EAGLE MOUNTAIN
PLANNING COMMISSION MEETING

FEBRUARY 11, 2025, 5:30 PM
EAGLE MOUNTAIN CITY COUNCIL CHAMBERS
1650 EAST STAGECOACH RUN, EAGLE MOUNTAIN, UTAH 84005

EAGLE MOUNTAIN CITY **PLANNING COMMISSION MEETING** **FEBRUARY 11, 2025**
TITLE:	Parkway Fields Subdivision Preliminary Plat H Approval Request
ITEM TYPE:	Preliminary Plat
FISCAL IMPACT:	n/a
APPLICANT:	Flagship Homes, Luke McColm representing

EAGLE MOUNTAIN CITY **PLANNING COMMISSION MEETING** **FEBRUARY 11, 2025**
TITLE:	Pinnacles B-3 project - Master Site Plan and Preliminary Plat
ITEM TYPE:	Master Site Plan
FISCAL IMPACT:	n/a
APPLICANT:	Century Communities; Toby Cordova representing

Scale:	1"=60'	Drawn:	BW
Date:	07/03/2024	Job #:	24-0230
Sheet:	L1.0

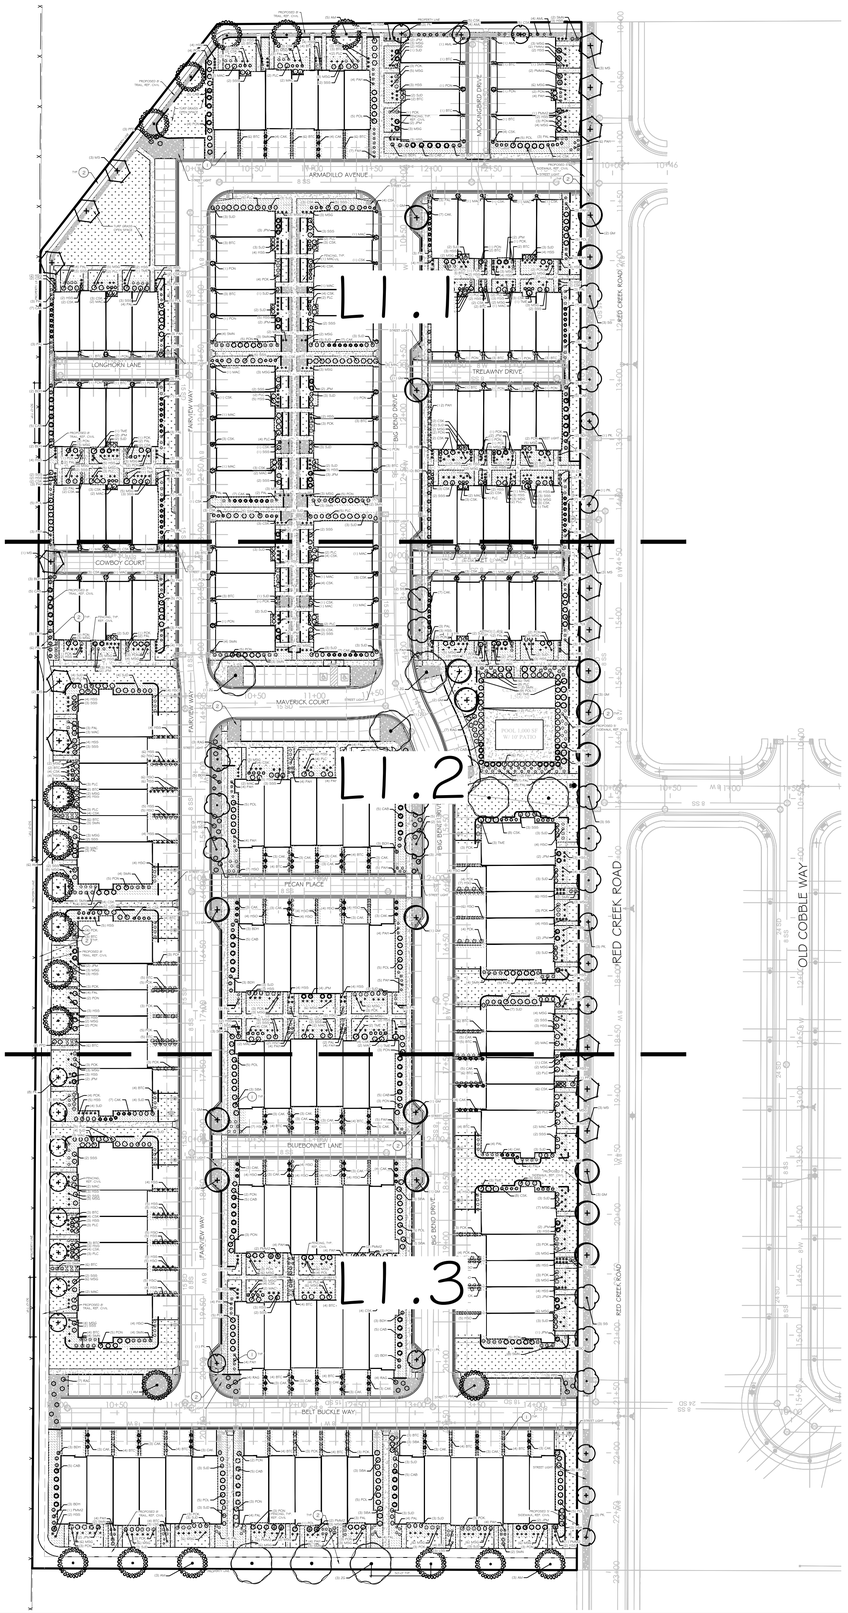
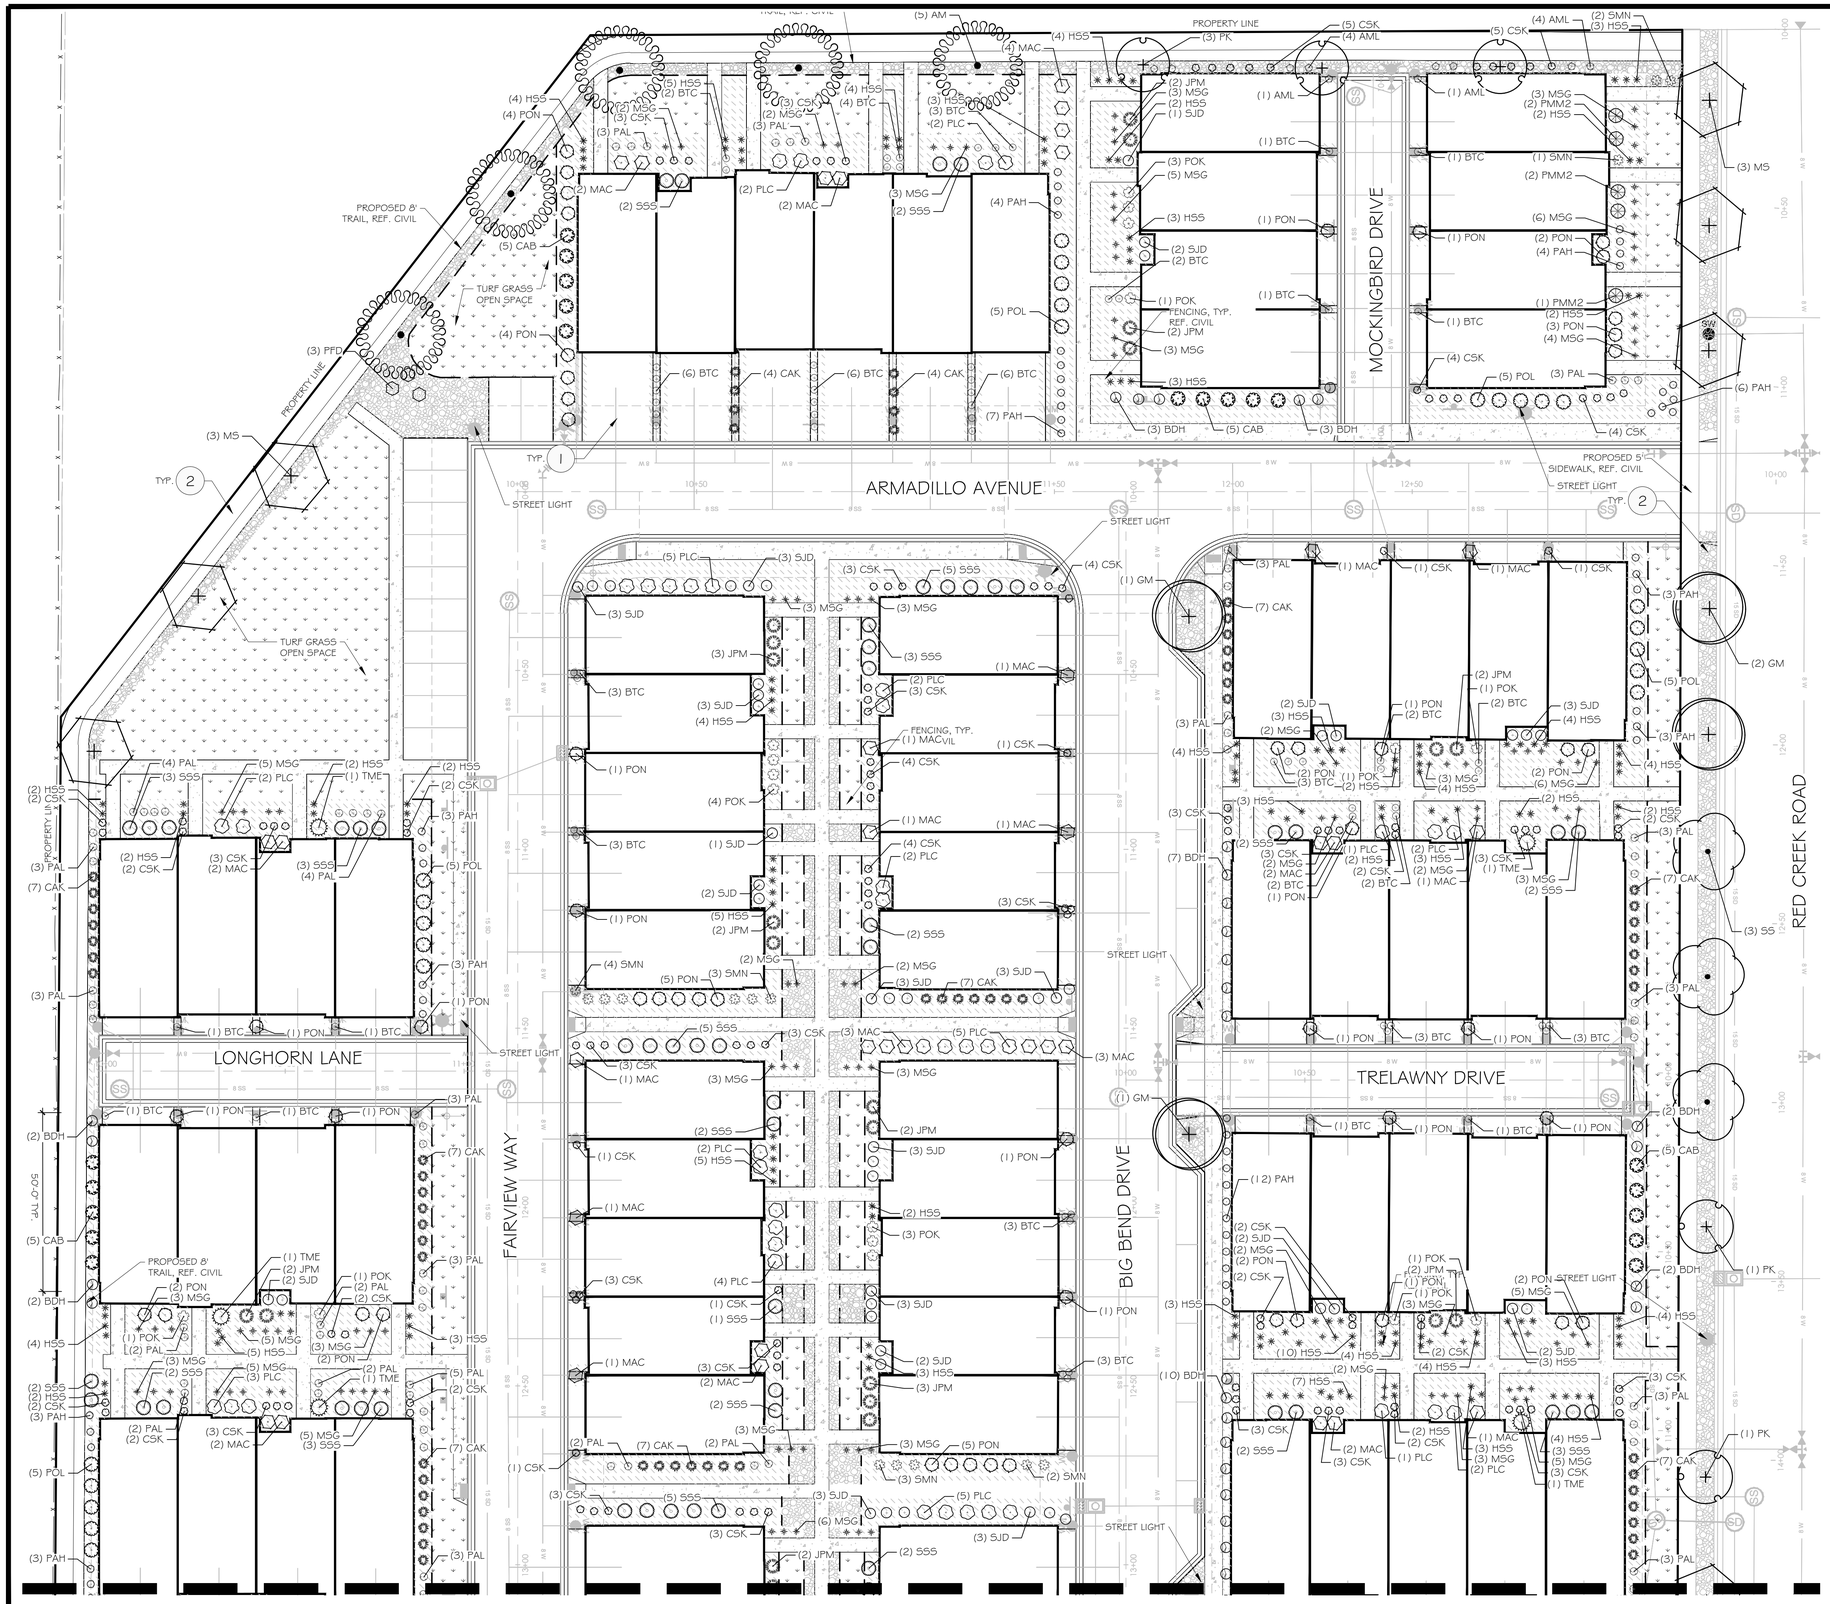
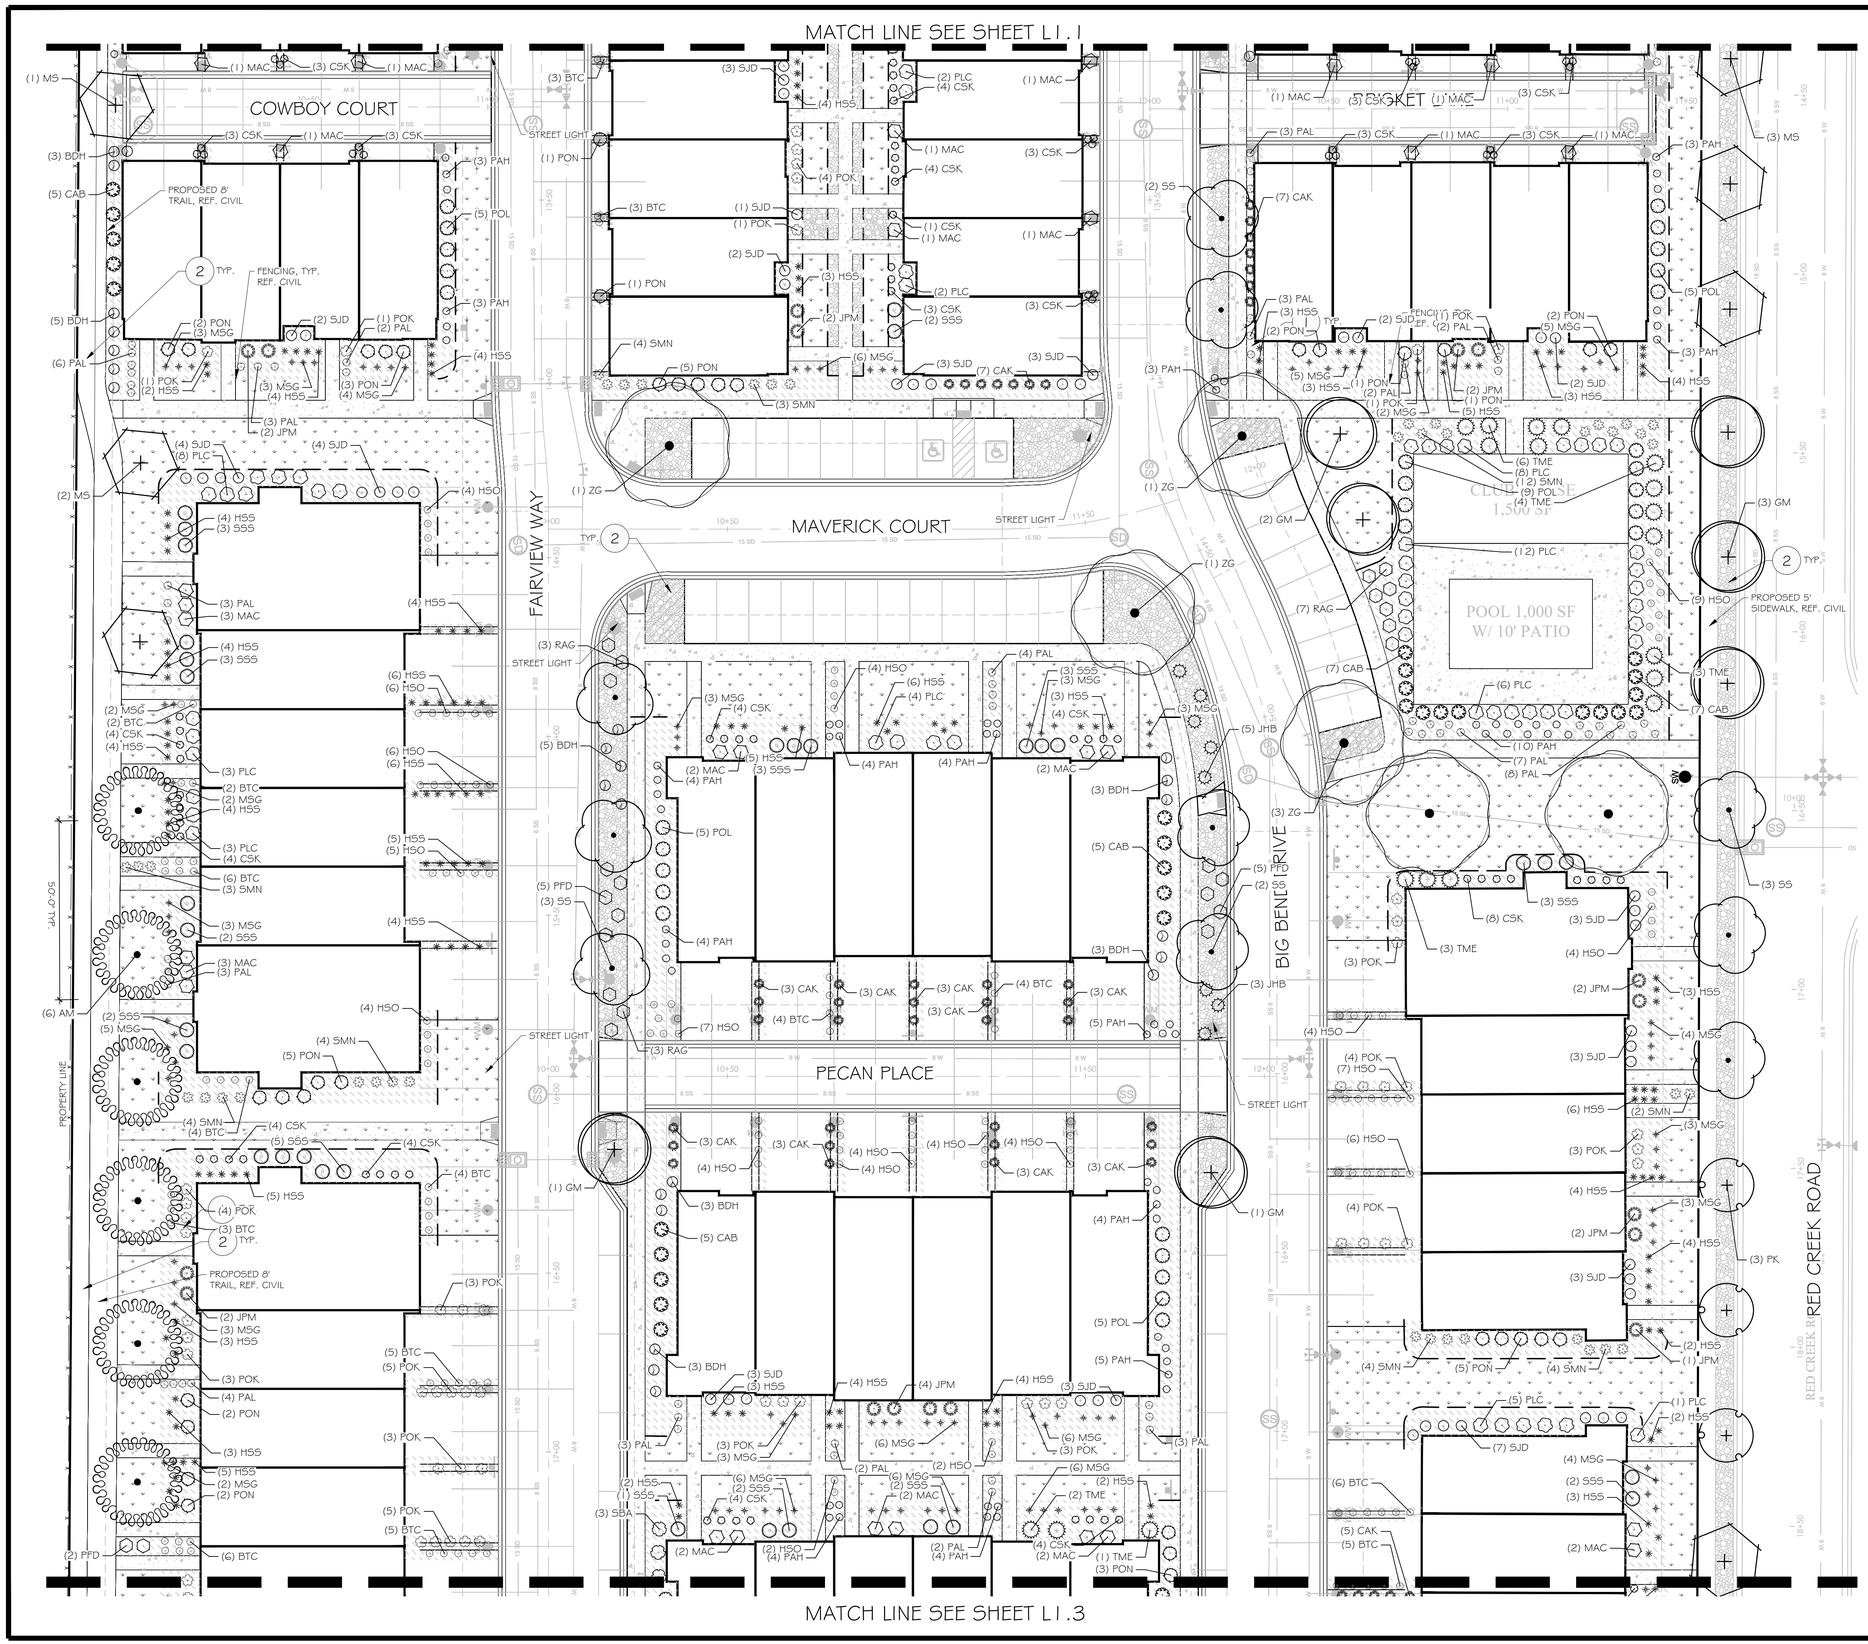
7. Demonstration that at least 594 open space amenity points as per EMMC 16.35.100.B. are achieved by provision of amenities listed in EMMC Table 16.35.130(c). Amenities shall be illustrated and labeled on (the) landscape plan(s) if not already, and a separate document shall be provided to City Staff outlining amenity point compliance.

8. All plan page revisions/corrections listed in Conditions 1-7 above shall be provided on a revised set of plan drawings to be provided to the City prior to the Master Site Plan being presented to the City Council and shall be made part of the requirements of the project's development/build-out.
